PLAN COMMISSION/HISTORIC PRESERVATION COMMISSION WEDNESDAY, APRIL 22, 2020

From: [Robert Wright](#)
To: cdi@chorus.net; [Nic Owen](#); [Kathy Hagen](#)
Cc: [Mike Slavney](#); [Michael Rochon](#)
Subject: RE: Updated Preliminary and Final Plats for Sixth Addition to Kara View Heights
Date: Monday, April 20, 2020 9:16:15 AM

To: Village of Mount Horeb Plan Commission
From: Village Planner Michael A. Slavney, FAICP
Date: April 22, 2020
Re: Village Planner's Preliminary Site Plan and Design Review Comments for Proposed Casey's Convenience Store, Gas Station, and Car Wash for April Plan Commission

PRELIMINARY PLAT OF SIXTH ADDITION TO KARA VIEW HEIGHTS

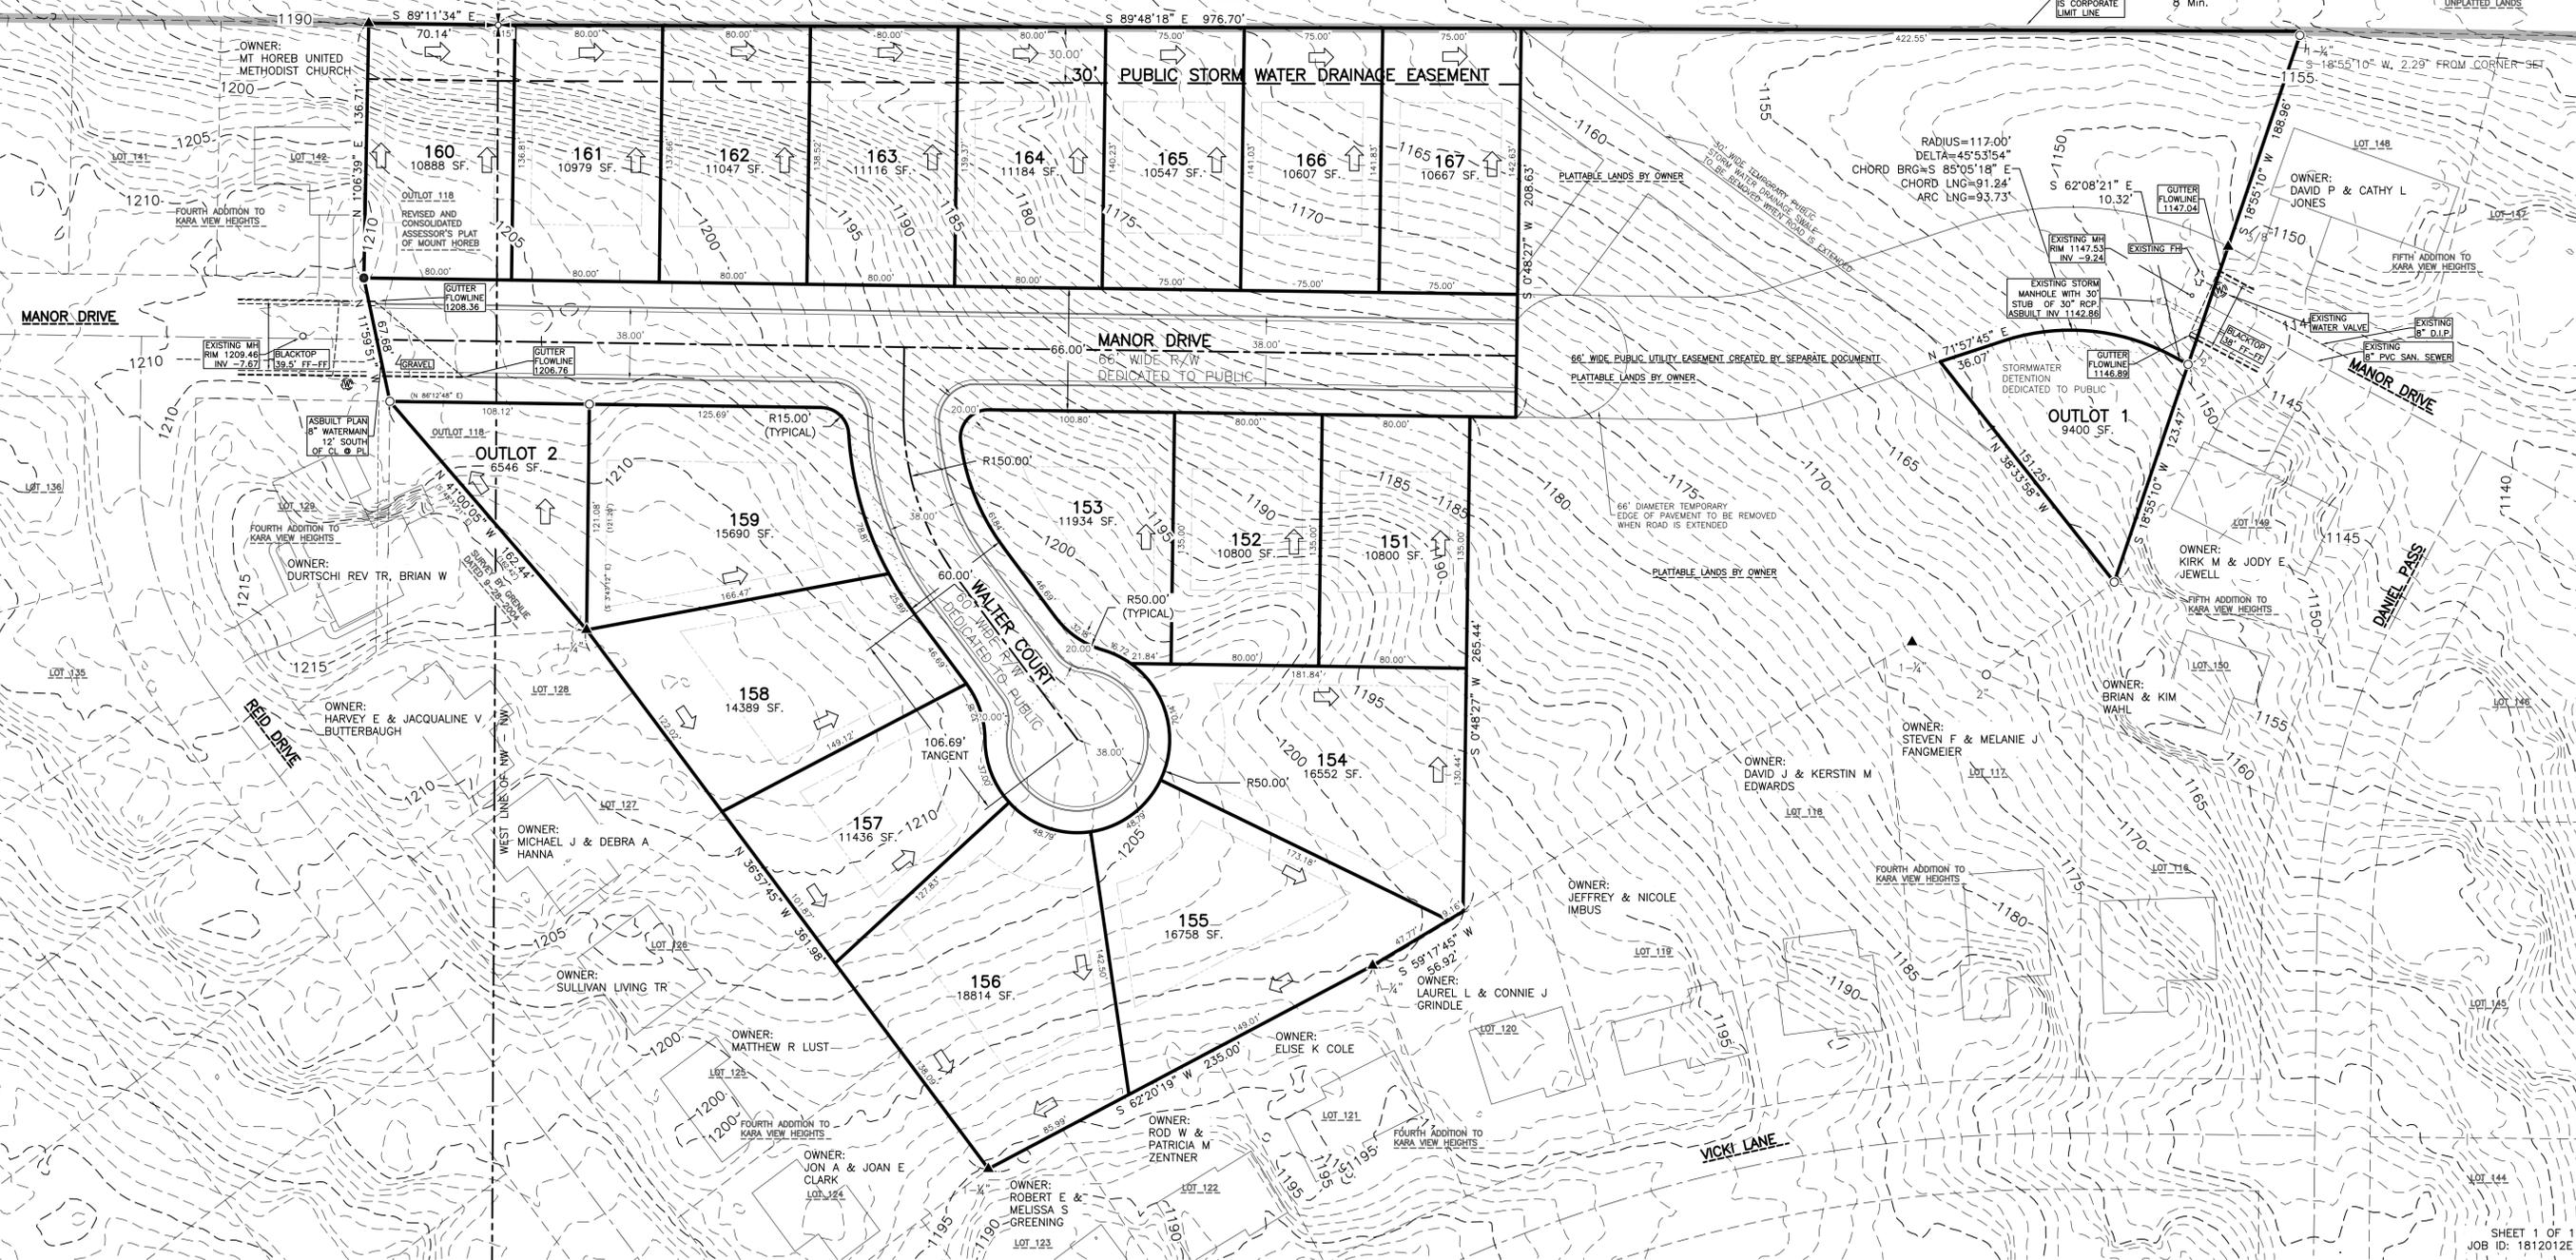
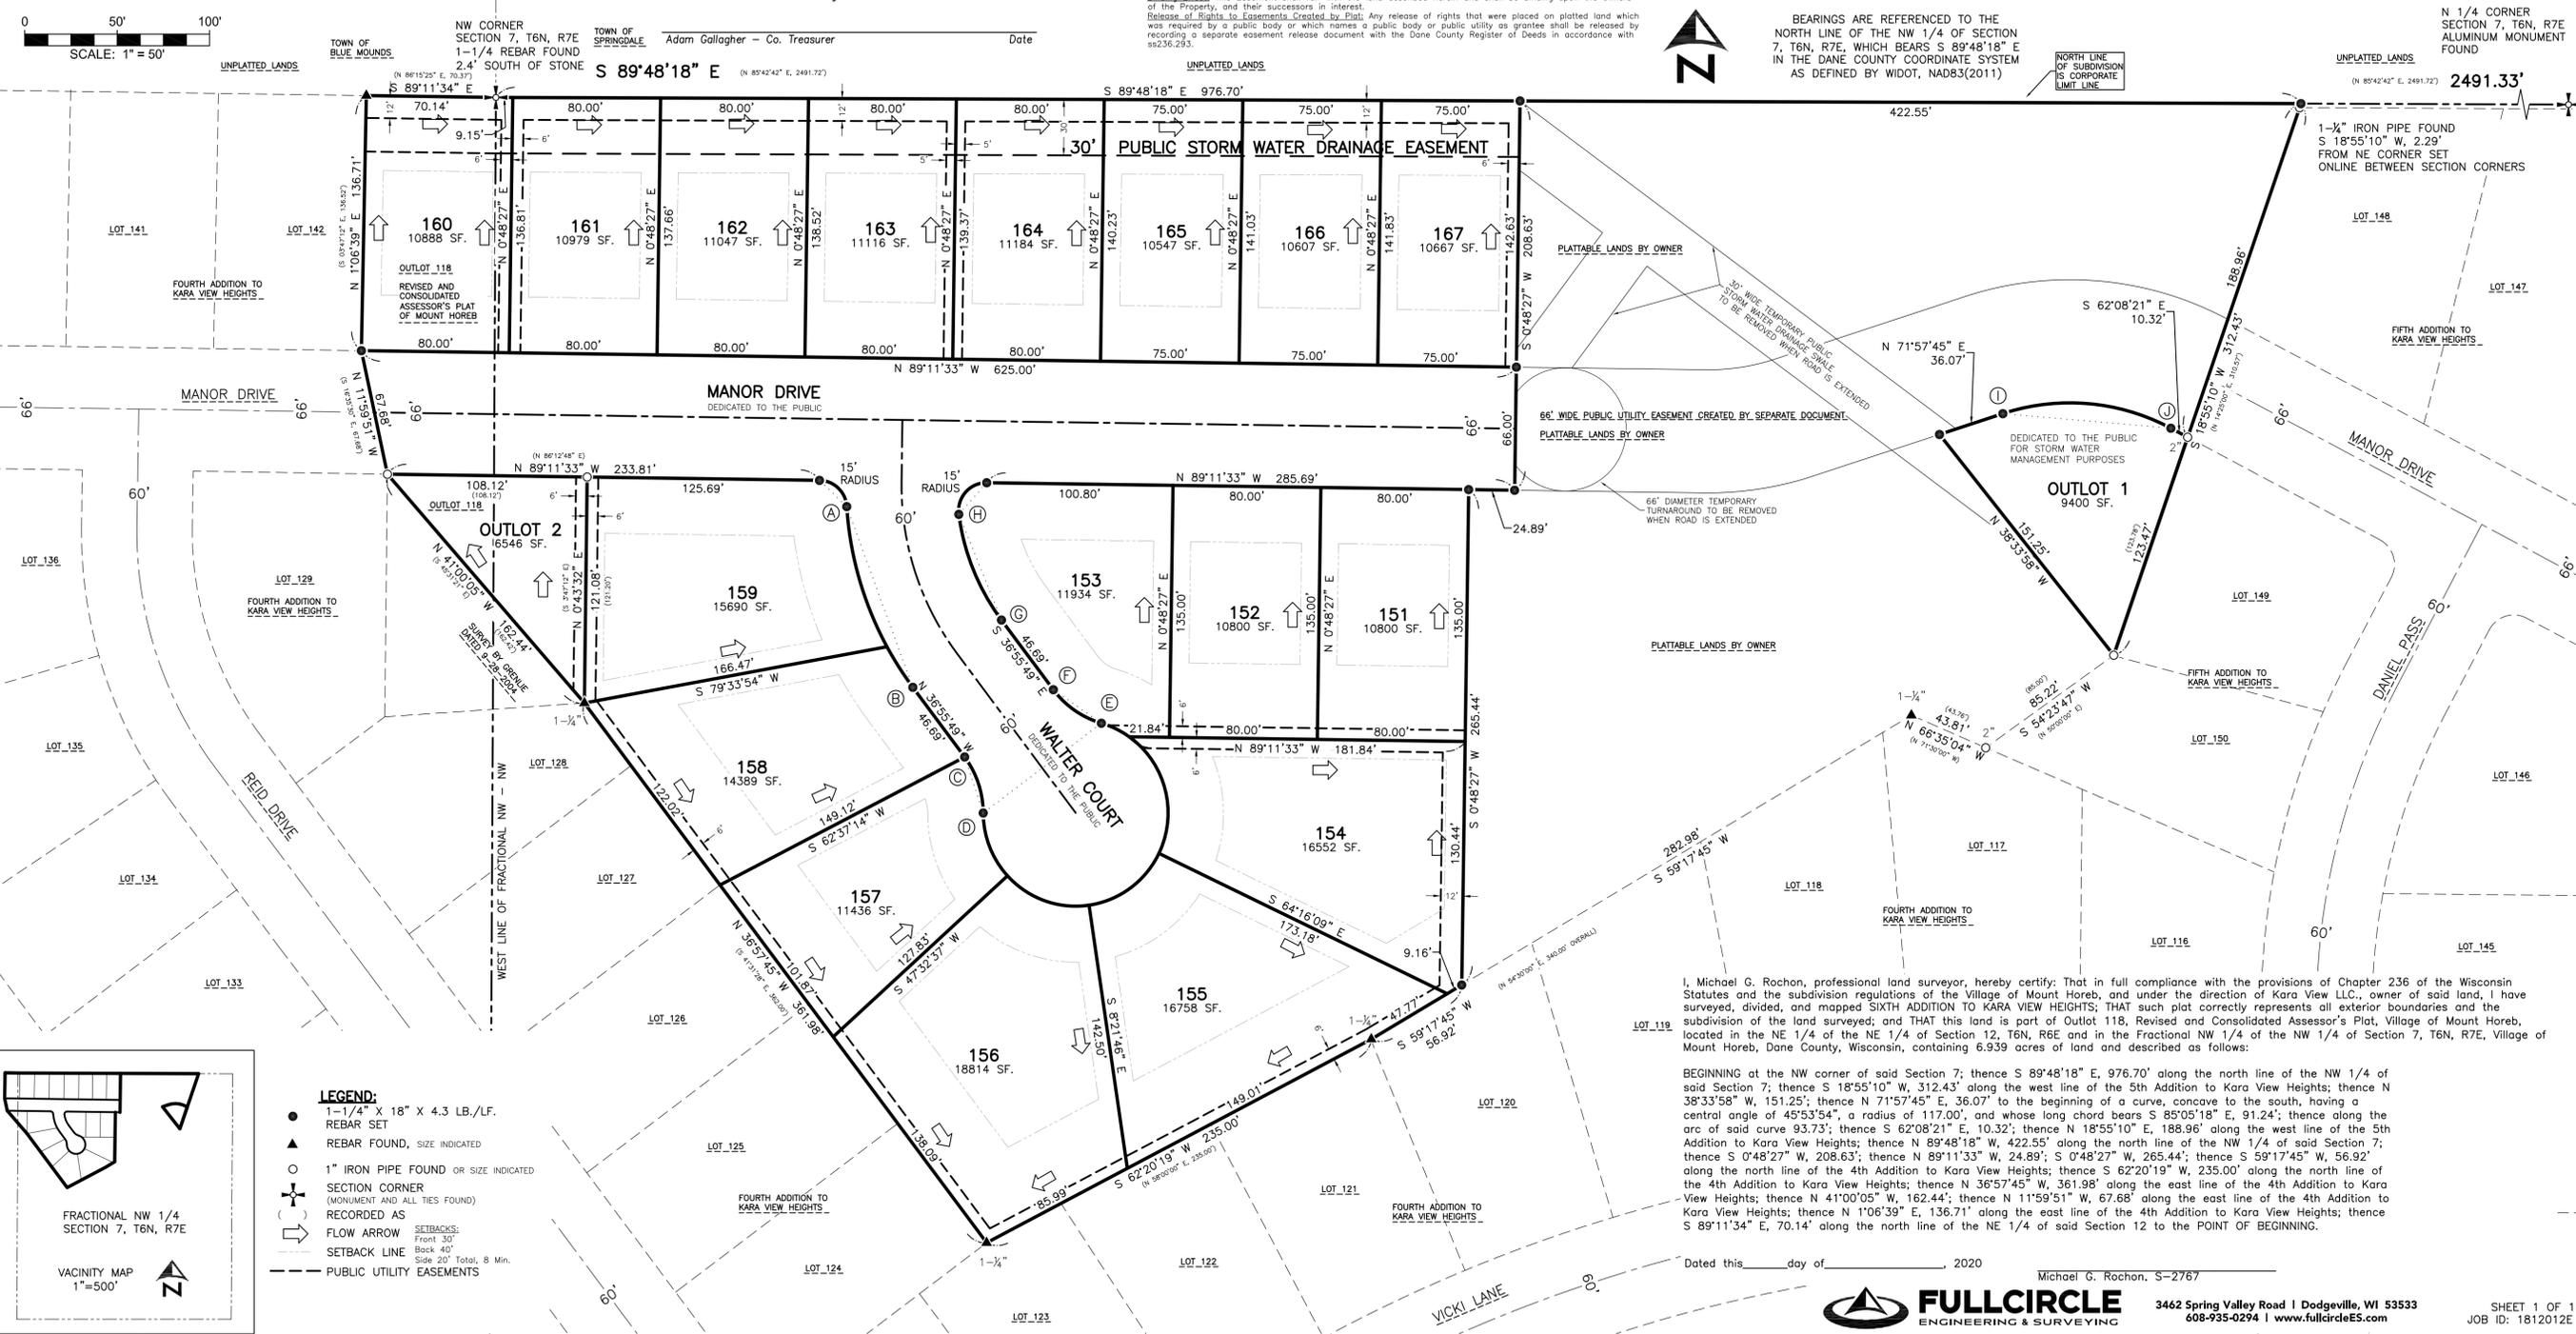
1. Stormwater management draft report
 - a. Appears to meet the intent of matching runoff rates
 - b. Verify that all grading for the Pond will fit on the platted Outlot 1 (see para. c.ii. below)

- c. Will require full report and check lists etc.
 - i. Swale will need to be engineered to convey flow to Outlot 1
 - ii. Cross section of berm for detention basin with proper impervious liner (clay or geotextile) berm width to allow for maintenance and design of broad crested berm

- d. Predevelopment Area names – match with Area Names in HydroCAD model in final report –
 - i. Example: 5S KARA YARD node. The Label KARA YARD appears twice in the model Post Dev. Model nodes and is listed as KARA UNDISRURBED on the W2 Post Development Map

- e. We still will require a buffer strip along the back lot lines of 155 and 156 due to numerous concerns raised by the adjacent property owners.
1. P-Plat

- a. Buffer strip noted on the plat (covenant)
 - b. Notes relating to all impervious surface water and roof runoff to directed to Walter Court for Lots 155 thru 157.

2. Final Plat
 - a. Buffer strip noted on the plat (covenant)
 - b. Notes relating to all impervious surface water and roof runoff to directed to Walter Court for Lots 155 thru 157.

Having said this we would support the contingent approval of the P-Plat and Final Plat by the Village with the previous items being completed prior to recording.

SHEET
GS-1

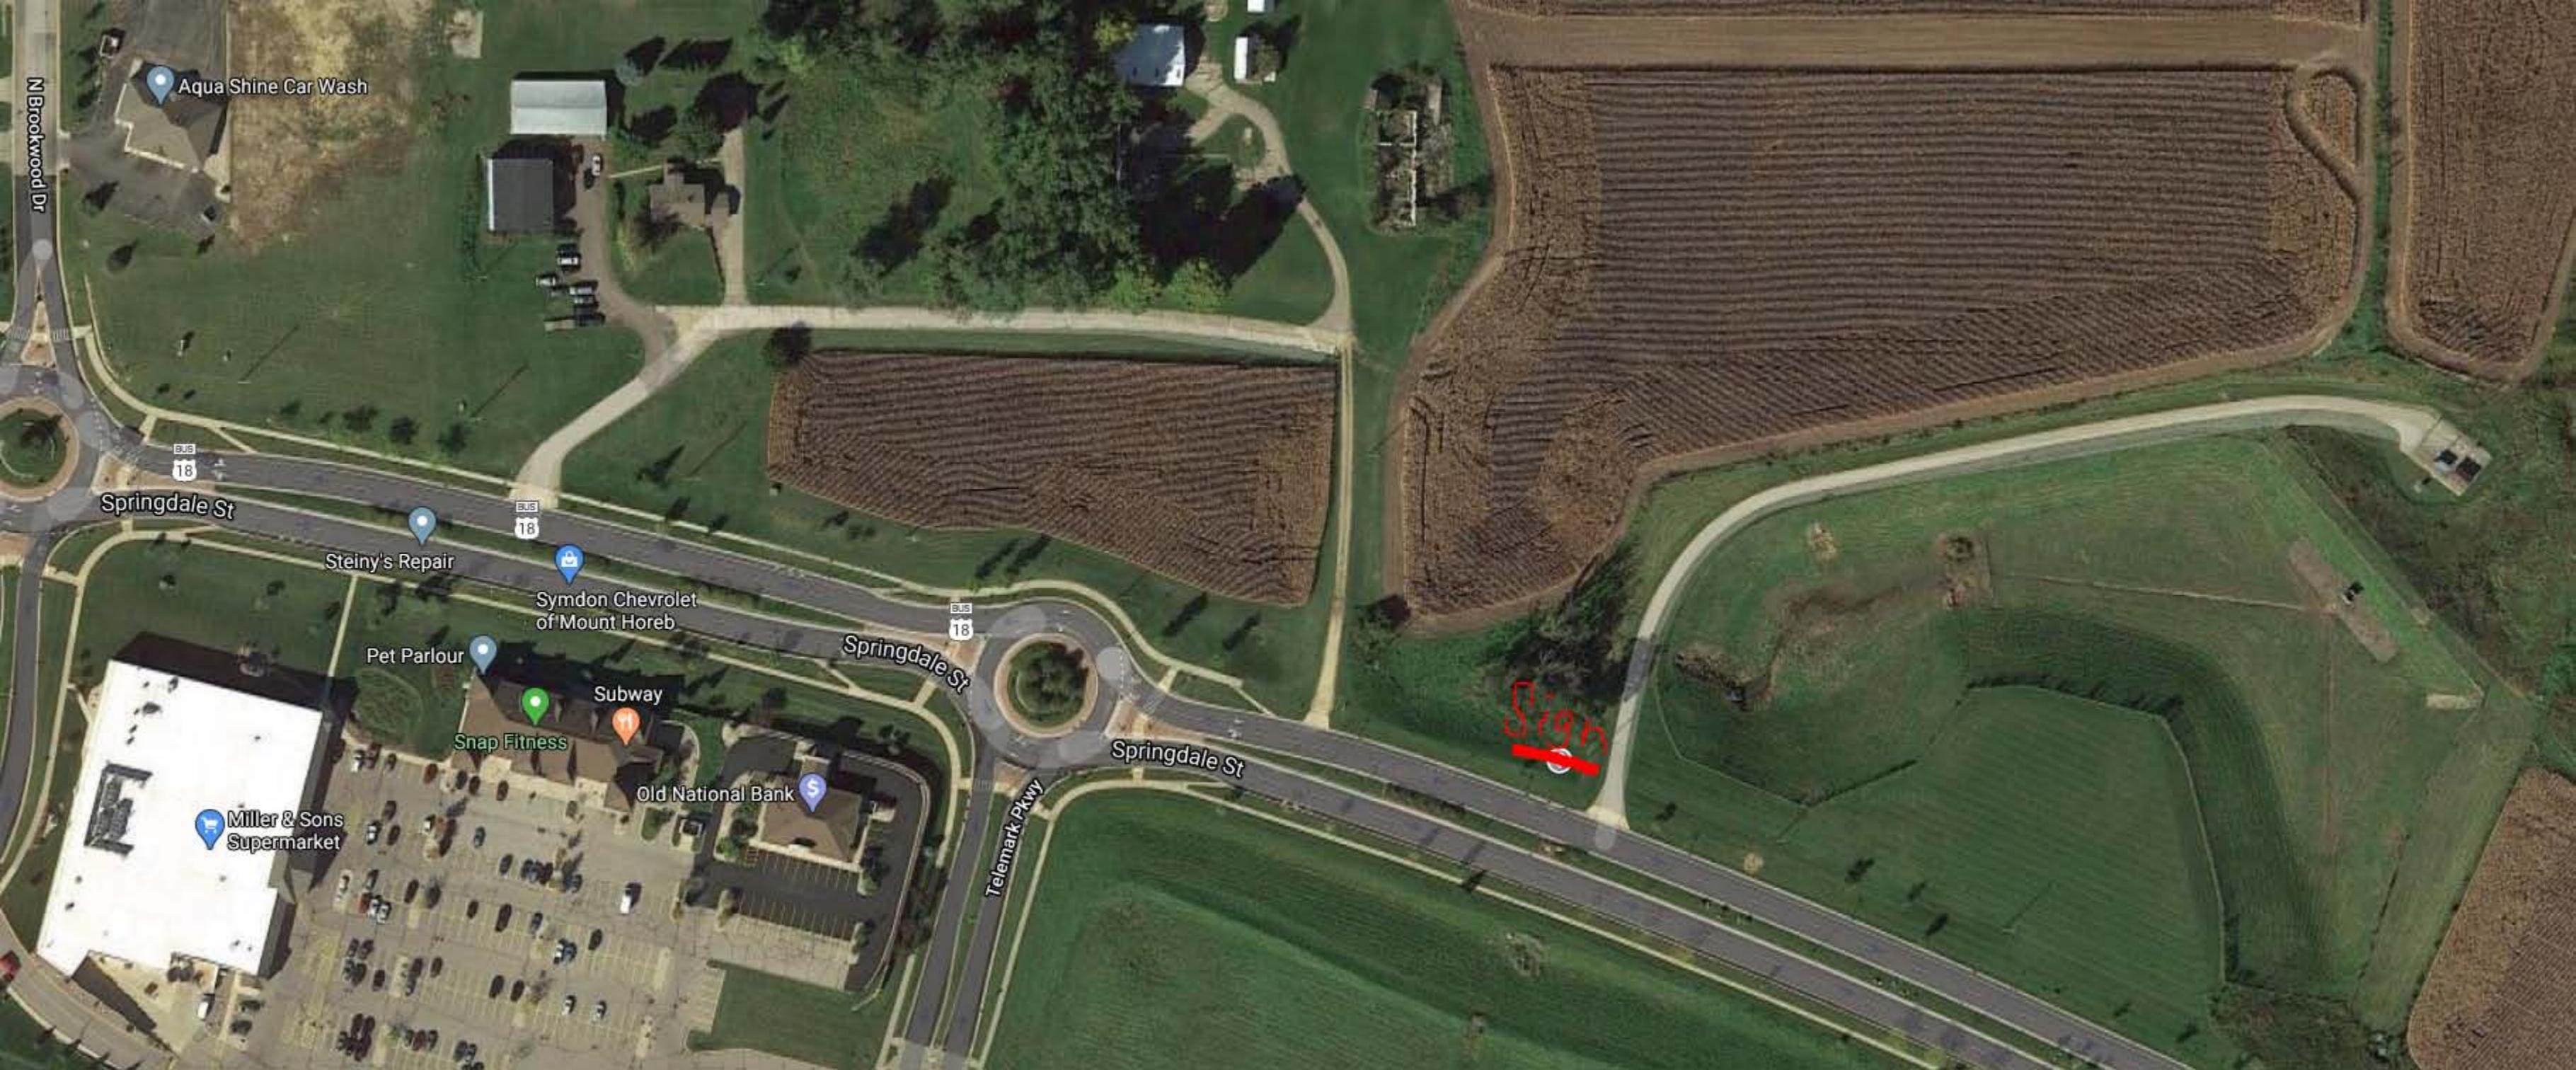
- Site Design:
 - Village Public Works Director and Village Engineer should review and approve the proposed location of freestanding sign near corner of Springdale and Lillehammer, keeping in mind its maximum permitted height of 12 feet and sight line concerns. Does the Plan Commission have any other concerns with the proposed location?

CASEY'S
GENERAL STORE

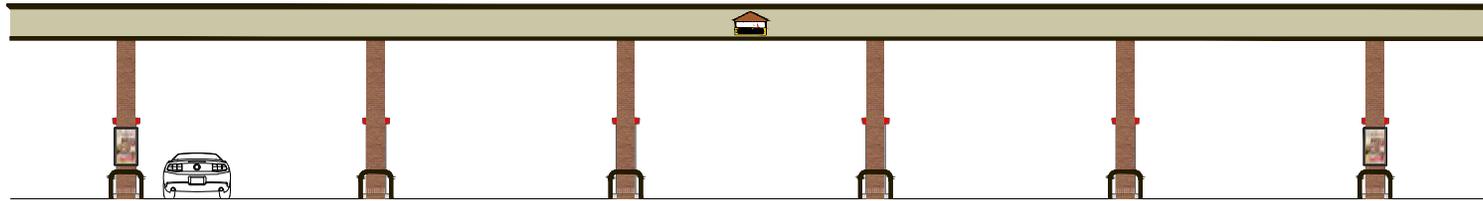
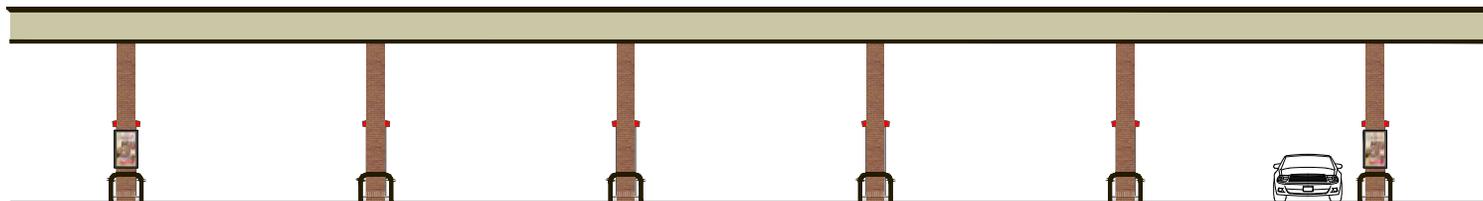
- a. Long building facades shall be visually broken up and variegated with staggers and offsets as determined appropriate by the Plan Commission.
 - This requirement is met on the front. Does the Plan Commission think this requirement is met on the back (west facing) façade?

- I think this requirement is met on the front. Does the Plan Commission think this requirement is met on the north-facing façade facing Springdale Street?

- This requirement is met on all portions of the building using calm, neutral colors – except for the proposed stripe on the canopy. Does the Plan Commission wish to consider an exception to this requirement for the canopy stripe?

- a. All exterior doors visible from streets, drives or parking areas shall provide decorative design elements.
 - This requirement is not met on the man doors on the north and west facades, which are visible from Springdale Street. Does the Plan Commission wish to consider an exception for this prohibition?

- This requirement may not be met on the highly visible rear west façade of the building. The proposed rear roof is a substantial upgrade from the originally proposed treatment. Does the Plan Commission feel this requirement is met by the proposal; or alternatively, does the Plan Commission wish to consider an exception to allow the proposed approach?

- d. Rooftop mechanical equipment shall not exceed the elevation of the lowest point of the surrounding building parapet or roof.
 - This requirement is not met on the rear side of the roof. However, the roof is proposed to use screening panels to conceal views of the rooftop mechanicals. Does the Plan Commission wish to consider an exception to allow the proposed panels?
